IC Corporation

REVISED RECALL NOTICE

IC CORPORATION RECALL # 03305-R1
NHTSA RECALL # 03V- 354

Roof Topping Sheet Joints

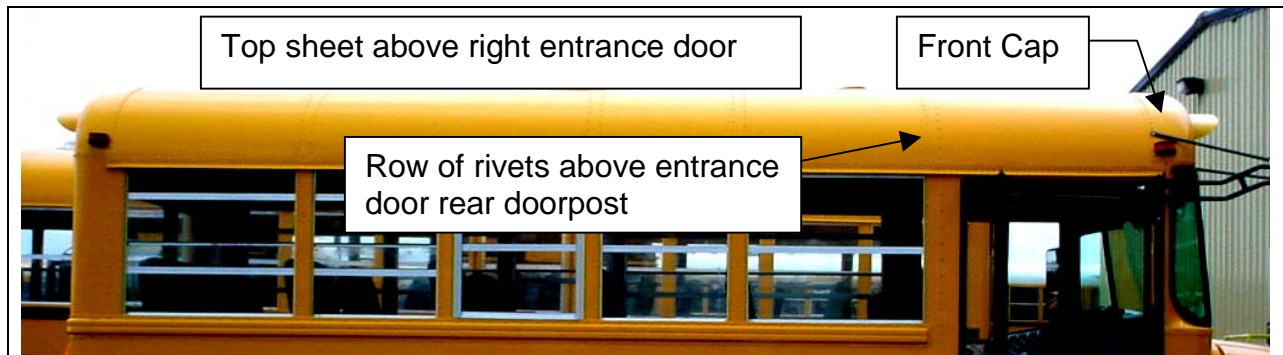
<p>Most Rear Top Sheet</p> <p>Drip Rail</p>	 <p>20-inches</p>
<p>Start with the most rear top sheet.</p>	<p>Measure up approximately 20-inches from the drip rail. The inspection measurement can be taken on either the right or left side of the bus. Only one side is required.</p>
 <p>Oozed Sealer</p> <p>Back Edge Of Top Sheet</p> <p>First Row Of Rivets</p> <p>1 1/8 (1.12) inches Maximum Measured</p>	
<p>Measure the distance from the back edge of the top sheet to the centerline of the first row of rivets. Note the most rear top sheet is attached to the rear cap with only one row of rivets and the measurement is taken to that row of rivets. If this distance exceeds 1 1/8 (1.12)-inches the next joint, which contains the covered end of the same sheet involved in the measurement, may be noncompliant and must be repaired. Make sure that the measurement is from the edge of the metal and not the sealer that may have oozed from the joint. If it is equal to or less than 1 1/8 (1.12)-inches, the joint is compliant and does not need to be repaired.</p>

<p>Rear Cap</p> <p>Rivet line at the rear end of the top sheet</p> <p>Forward end of the same top sheet Note: This end of the top sheet is not visible.</p>	
<p>The 1 1/8-inch measurement at the rivet line at the rear end of the top sheet being measured determines if the joint at the forward end of the same sheet is compliant.</p>

There has been some confusion with regard to the inspection procedure for the top joint. The **INSPECTION PROCEDURE** instructions stated: "Measure up approximately 20-inches from the drip rail. The inspection measurement can be taken on either the right or left side of the bus. Only one side is required."

The instructions that were developed were intended to take into account the possible variation due to manufacturing from side to side. Therefore, it is **NOT** necessary to perform the inspection measurement on *both* sides of the vehicle.

However, regardless of which side of the bus the inspection is performed on, if it is found that the measurement does not fall within the 1 1/8 inch criteria, then that joint must be repaired per the instructions outlined in the letter. In this situation the screws only have to be added across the panel until the measurement does comply with the 1 1/8 inch acceptance criteria.

If only a few (3 or less) rivets at/or above the measurement location of 20-inches exceed the 1 1/8 inch criteria, **NO** repair is required.

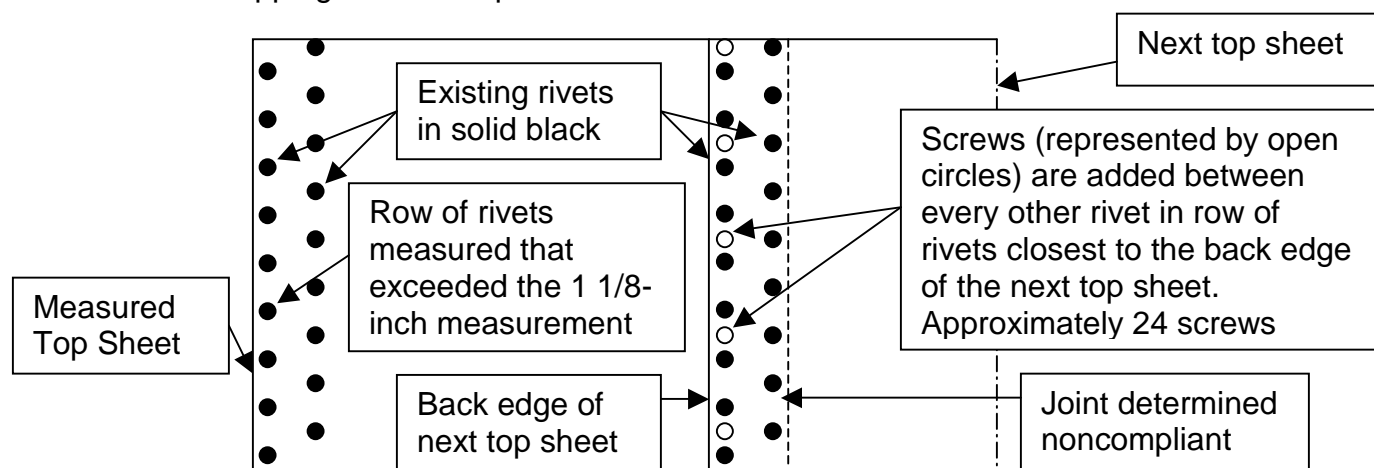
In-line with the rear most row of rivets in the non-compliant joint; screws must be added between every other rivet. See sketch below for an example. Drill a .1590 diameter hole (drill size 21) for each screw required. Insert the screw and use matching touch up paint if required. The screws that should be used for this repair are pre-painted either in white or yellow and have been dipped to provide sealing of the hole.
